IDFBDX AIR HEATER DOOR/CABINET EARTH LINK

This bulletin describes the method of fitting a flexible earth link cable between the control cabinet door and the control cabinet side wall on Nordair Niche IDFBDX heaters fitted with Mitsubishi FTC controllers. The serial numbers affected are shown in the table below:

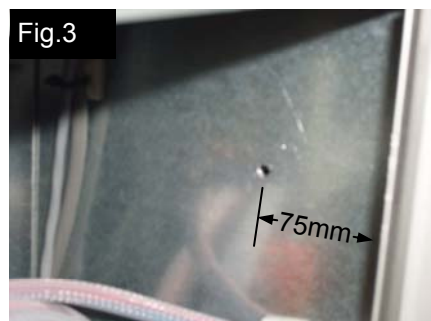
Secure the first crimp lug under the existing control lamp cover fixing screw as shown in Fig.2.

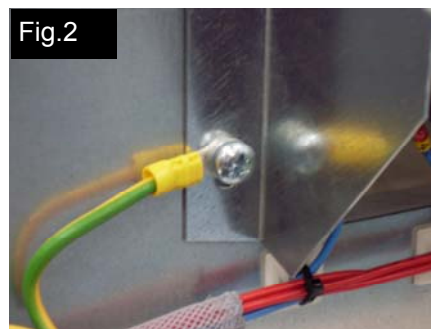
Mark and drill 1 x 6mm hole in the side wall of the control cabinet as shown in Fig.3 opposite.

Note: check inside the burner control cabinet (right hand cubicle) that the new hole is not too close to existing cables, conduit etc.

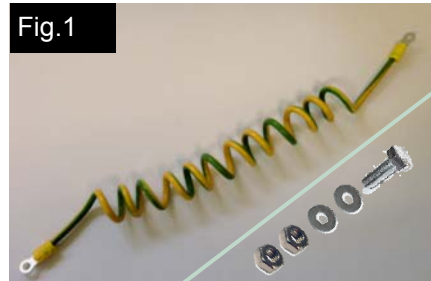
Fix the second lug using the 6mm pin, nuts and washers as shown in Fig.4.

Ensure the cabinet door can be fully opened, and that there is no undue strain on the cable.

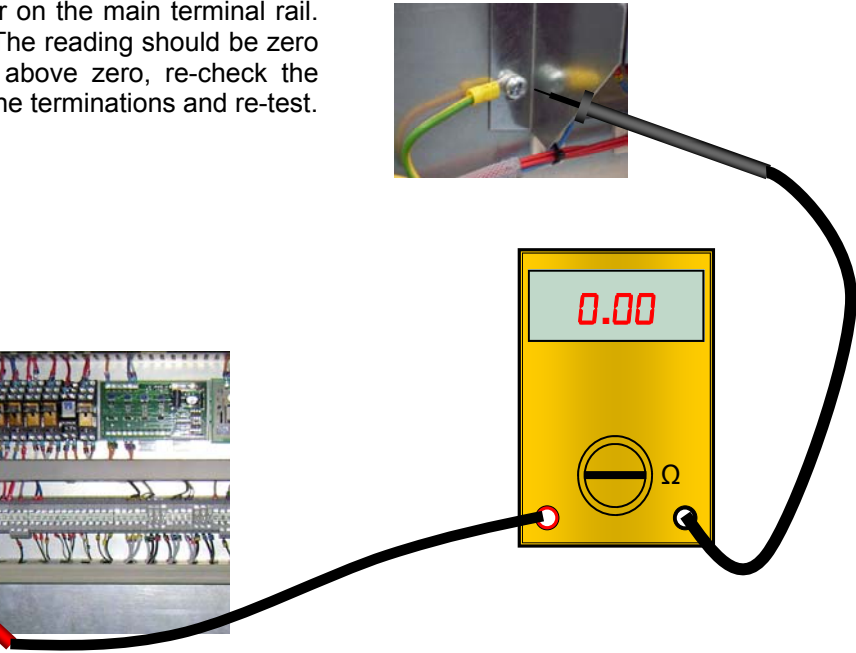
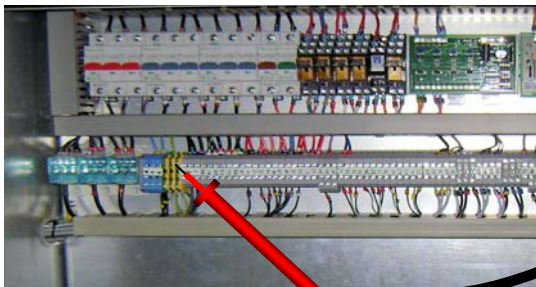
Using a multimeter with the lowest ohms range selected, check for continuity between the newly fitted earth ring terminal on the door and the incoming earth connector on the main terminal rail. (See illustration below). The reading should be zero ohms. If the reading is above zero, re-check the tightness/cleanliness of the terminations and re-test.
